Access Compliance Report

Public Rights-of-Way

| Intersection ID: 53181 | Main Street: GOODMAN_PARK_CT | Cross Street: BASIE_PARK_CT | Location: NW |
| ADA ID: 78AEAE1884FC | Ramp Type: PerpDiag | Initial Pass/Fail: Fail | Overall Compliance: No |

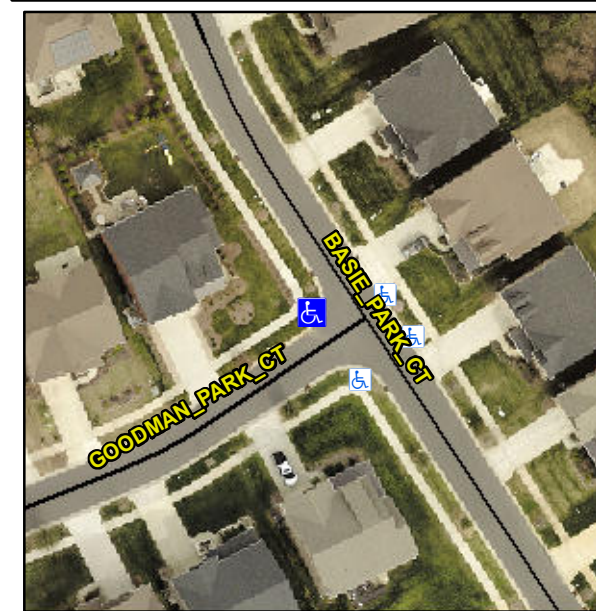
R304.5.1, R304.2.2, R304.5.3

| Compliance | Description | Data | Compliance | Description | Data |
|------------|-----------------------|-------|------------|-----------------------------|------|
| N/A | Ramp Length (in) | 97.0 | No | Ramp Slope (%) | 11.3 |
| No | Ramp Width (in) | 45.0 | No | Ramp XSlope (%) | 5.5 |

Remove & Replace Curb Ramp With Two New Directional Ramps or Equivalent.
